**City Council
Special Meeting
Agenda**

Business Item II.B
Litchfield Road Roundabout
Landscape & Irrigation

MOVE TO APPROVE A CONTRACT AMENDMENT TO THE EXISTING COOPERATIVE PURCHASING CONTRACT FOR CONSTRUCTION SERVICES WITH NESBITT CONTRACTING IN THE AMOUNT NOT TO EXCEED \$159,000 FOR ADDITIONAL CONSTRUCTION SCOPE ITEMS FOR LANDSCAPING AND IRRIGATION IMPROVEMENTS FOR THE LITCHFIELD ROAD/BRINTON AVENUE PROJECT AND AUTHORIZE THE MAYOR TO EXECUTE THE REQUIRED DOCUMENTS

Attn: Keith Drunasky
Project Location: Litchfield Road and Brinton Roundabout
Project Description: Landscape Change order

HARDSCAPE PLAN

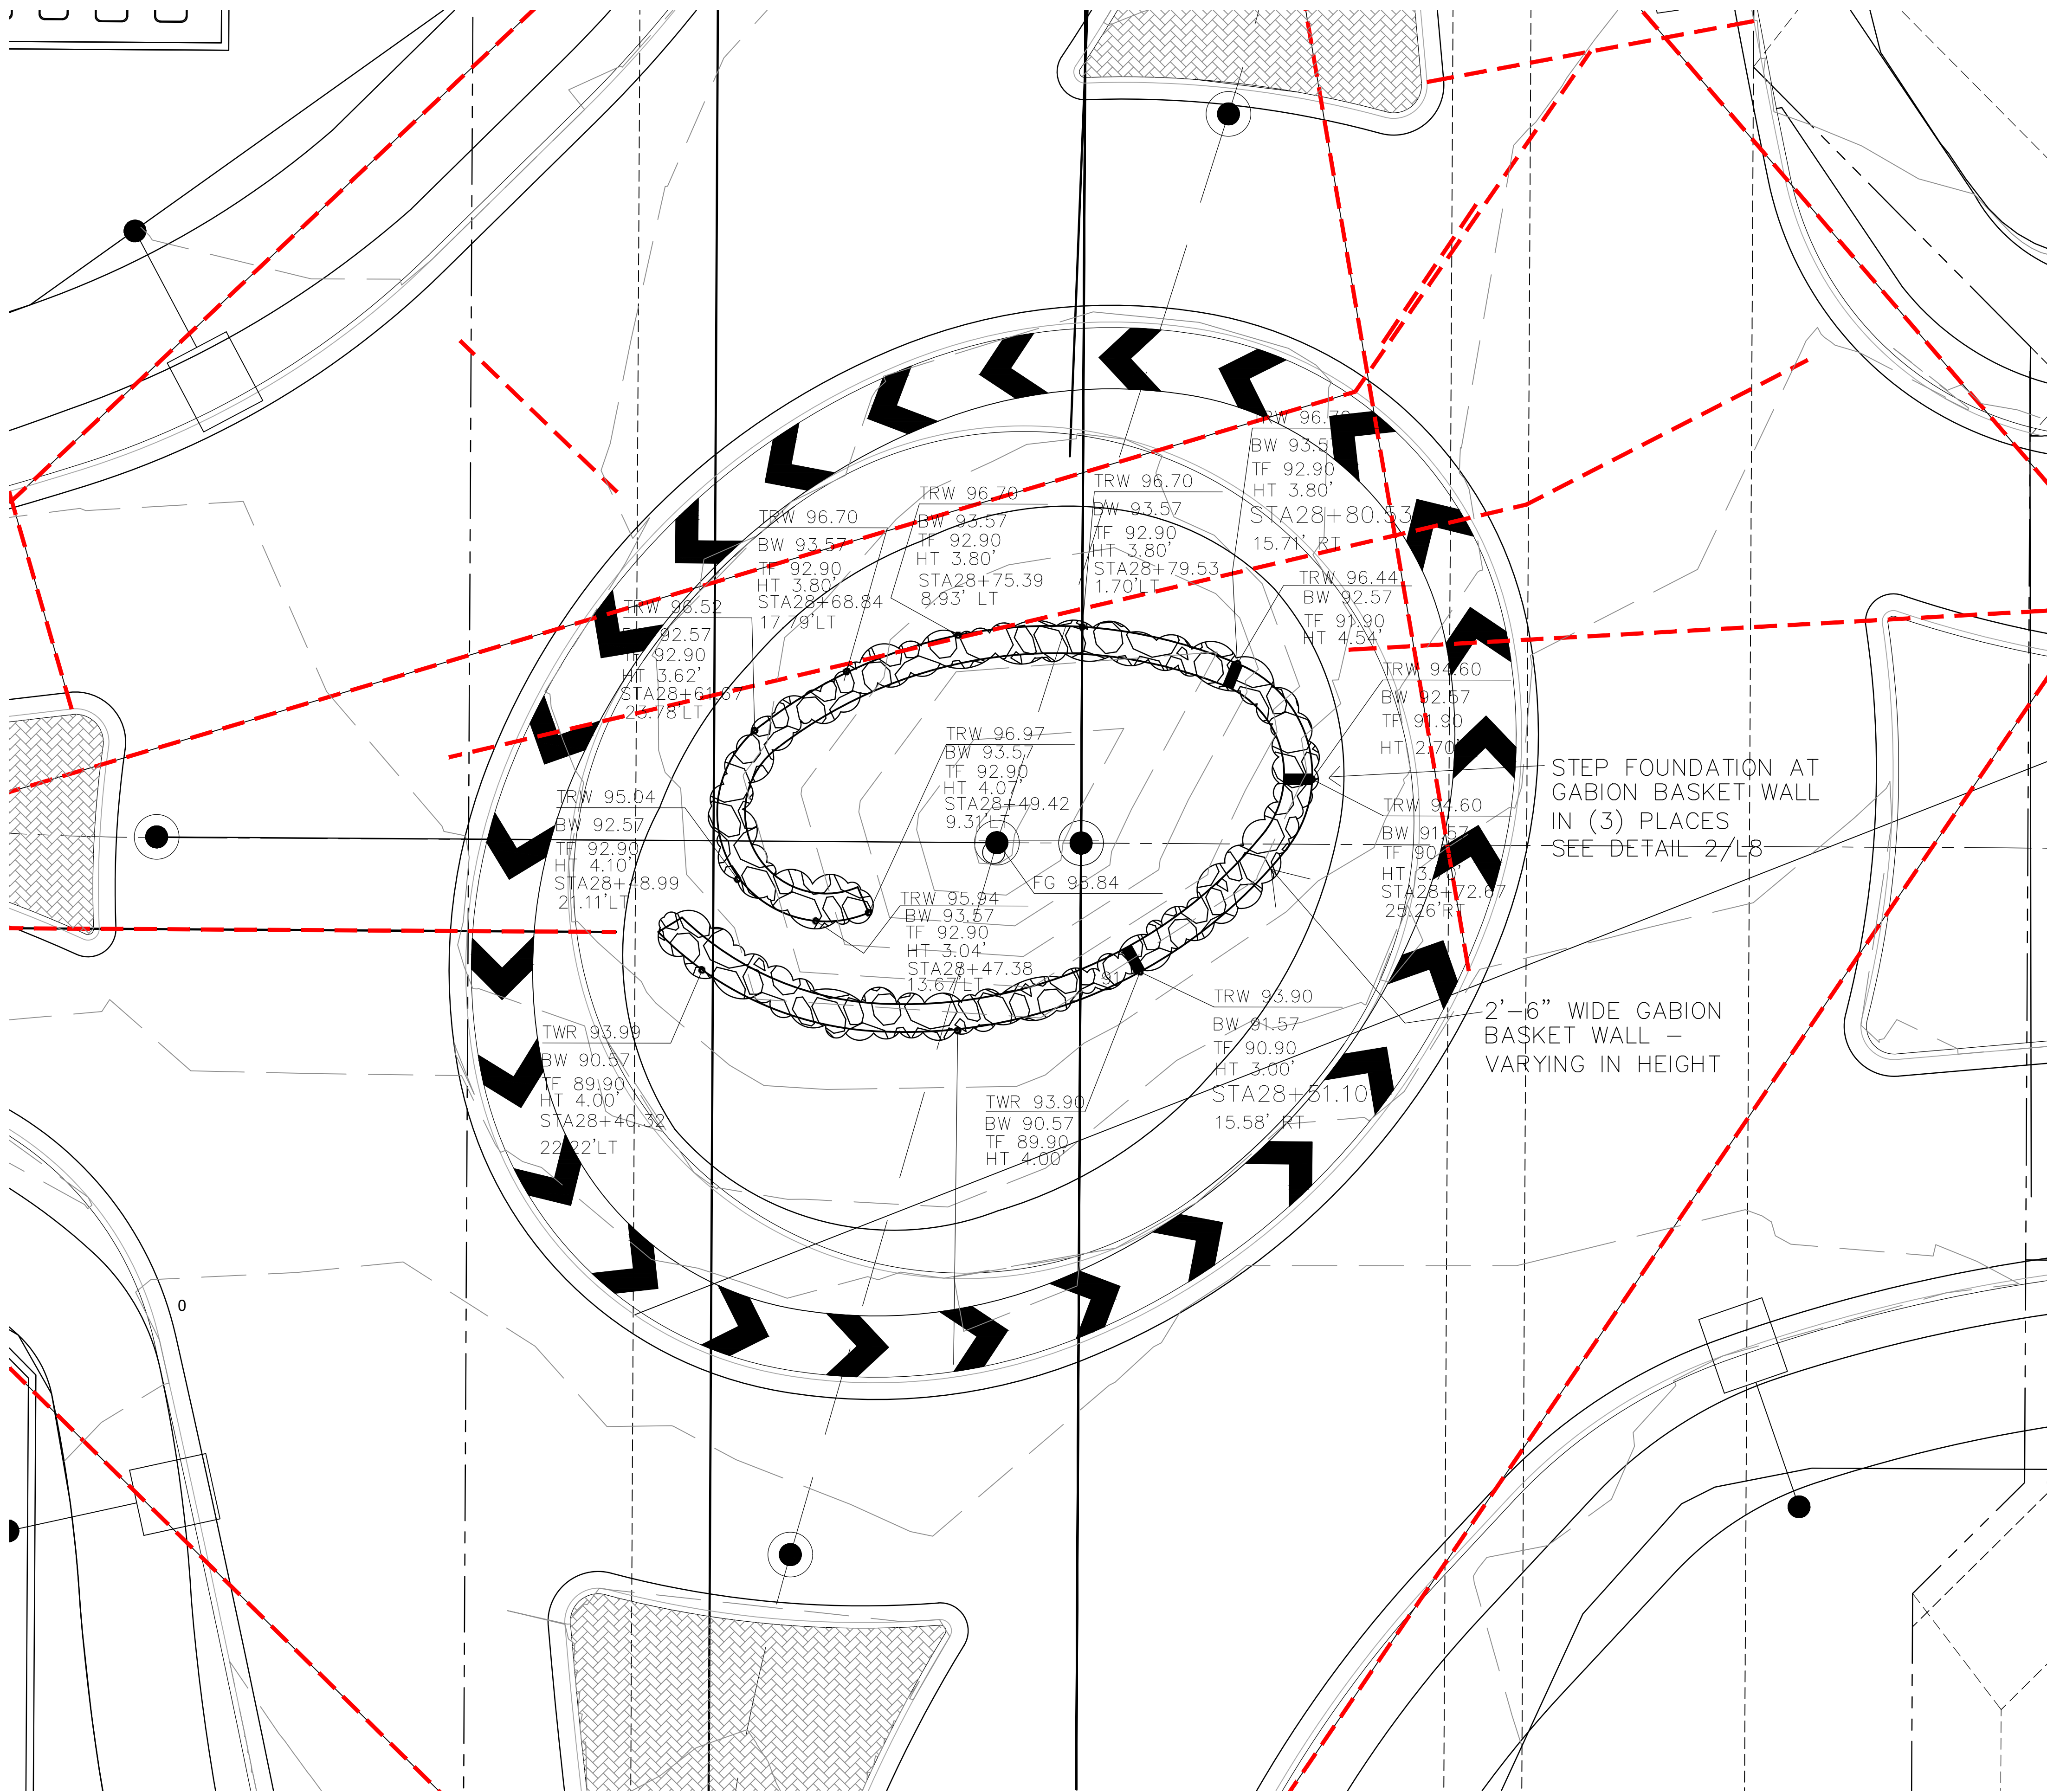
Staff proposes to delete all pavers scope (3,353.00 square feet, \$36,883.00) from the median areas and replace the same area with DG gravel (3,353 SF at \$1.50/SF) for a savings of \$31,853.50. With reduction of scope to replace pavers with DG gravel, an additional \$158,162.50 is necessary to complete all remaining landscape and irrigation improvements. In order to have a small contingency for unforeseen conditions, as presented, Staff is requesting an amount not to exceed \$159,000 for this item.

3.353 SF Pavers deleted from scope

38,070 SF increased to 41,423 SF to replace Pavers
